PLANNING COMMISSION AGENDA REPORT

SUBJECT: REVIEW OF A COMMON INTEREST VESTING TENTATIVE TRACT MAP (VTTM 3136), A 192-UNIT MIXED-USE DEVELOPMENT, INCLUDING 7 LIVE/WORK UNITS, A 585 SQUARE FOOT COMMERCIAL UNIT, ON-SITE PARKING, AND OTHER RESIDENTIAL COMMUNITY AMENITIES ON A 10.93-ACRE SITE LOCATED

PROJECT ADDRESS:
3580/3584 Bullock Lane

FILE NUMBERS: ARCH-0489-2019,
SBDV-0490-2019 & EID-0345-2020

Figure 13. Added lighting and rain cover awnings at garage door entrances.

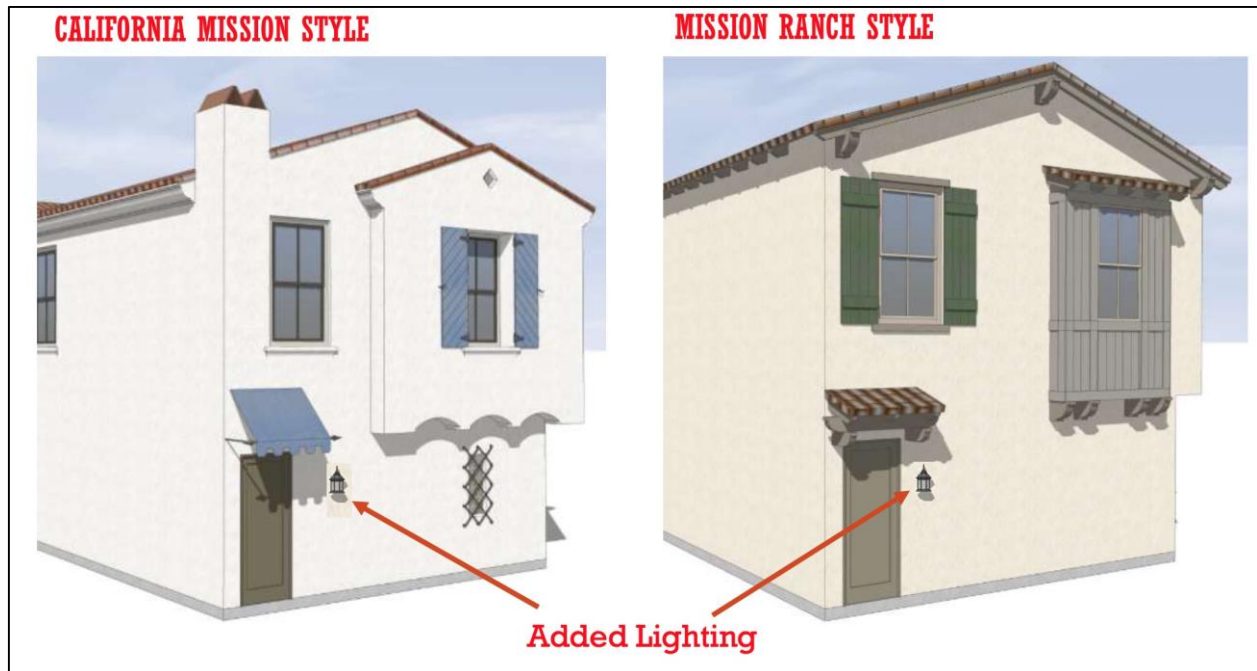
ARC Directional Item #1: Consider at least partially solid guardrails on apartment balconies. If metal railings are used on balconies, limit them to the upper portions of balconies to maximize privacy.

ARC Directional Item #2: Consider the use of masonry on porches on the front porches that provide the contrast that the designers are looking to achieve without making these necessarily solid veneer elements.

ARC Directional Item #3: Consider some sort of shelter above garage doors.

The applicant has provided additional details showing alterations to the balcony railings and the use of masonry on the porches, as well as additional lighting and sheltering elements for garage entrances in response to the direction provided by the ARC (see Figures 11, 12 and 13 below).
